HISTORIC AND DESIGN REVIEW COMMISSION

November 07, 2018

HDRC CASE NO: 2018-549
ADDRESS: 311 W HUISACHE AVE
LEGAL DESCRIPTION: NCB 3001 BLK 3 LOT 20
ZONING: R-4 H
CITY COUNCIL DIST.: 1
DISTRICT: Monte Vista Historic District
APPLICANT: Kevin Morris
OWNER: Dewitt Van Wisse
TYPE OF WORK: Exterior modifications, porch modifications
APPLICATION RECEIVED: October 13, 2018
60-DAY REVIEW: December 12, 2018
REQUEST:

311 W Huisache
Front elevation

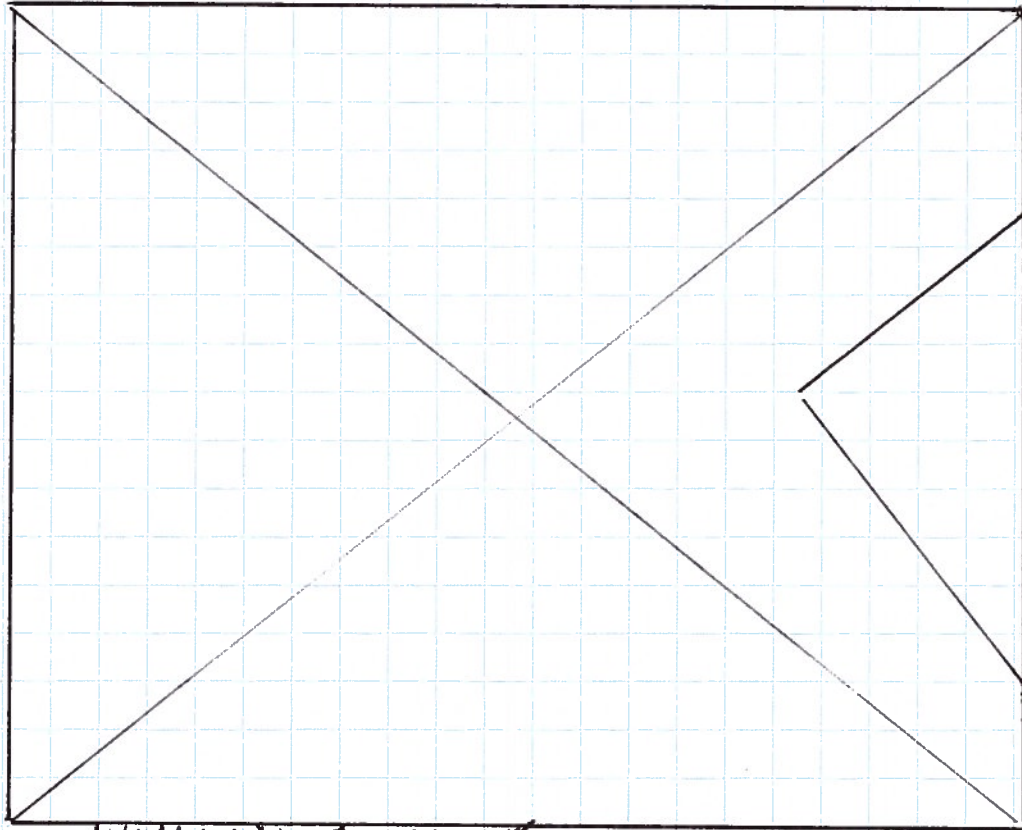
- b. DOOR REMOVAL – The applicant has proposed to enclose an existing non-original, front-facing door with siding to match the material and profile of existing. The door is located on a side addition, which was originally an open porch per Sanborn Maps. According to Guideline 6.A.i for Exterior Maintenance and Alterations, historic openings should be preserved. While the door opening is not original to the structure, the enclosure and adding of continuous siding would create an uninterrupted expanse of siding that is uncommon for street-facing facades in the district. Staff finds that the installation of a window would be more appropriate and would retain a more familiar façade elevation.

- c. PORCH COLUMNS AND RAILING – The applicant has proposed to install a simple wooden railing on the existing front porch with 6x6” wood columns. Per the submitted drawing, the railing will feature simple balustrades measuring 36” tall with a flat top rail. The columns will feature an 8” tall footing and an 8x8” top plate. According to the Historic Design Guidelines, new porch elements should complement, but not visually compete with, the existing structure. Staff finds the proposed concept appropriate, but requires a full porch elevation and plan prior to issuing a Certificate of Appropriateness.

- d. PORCH ROOF – The applicant has proposed to install a new low-sloping metal roof on the front porch. The roof will replace an on-original metal awning structure and will be supported by the proposed new columns. The footprint of the roof will generally match that of the existing awning structure. According to the Historic Design Guidelines, new porch elements should complement, but not visually compete with, the existing structure. While Sanborn Maps do not indicate a formal front porch structure, staff finds that the proposal is reversible and is compatible with the existing architecture.

Item 1, Staff does not recommend approval of the door enclosure based on finding b. Staff recommends that the applicant installs a window that is consistent with the size, proportions, configuration, inset, and detailing as those on the original structure or similar to those in the district. The applicant is required to submit a window specification and updated elevation to staff for review and approval prior to receiving a Certificate of Appropriateness.

Item 2, Staff recommends approval of the front porch railing installation based on finding c with the stipulation that the applicant submits final dimensioned drawings to staff for review and approval prior to receiving a Certificate of Appropriateness.

Item 3, Staff recommends approval of the new front porch roof based on finding d with the stipulation that the applicant submits final dimensioned drawings to staff for review and approval prior to receiving a Certificate of Appropriateness.
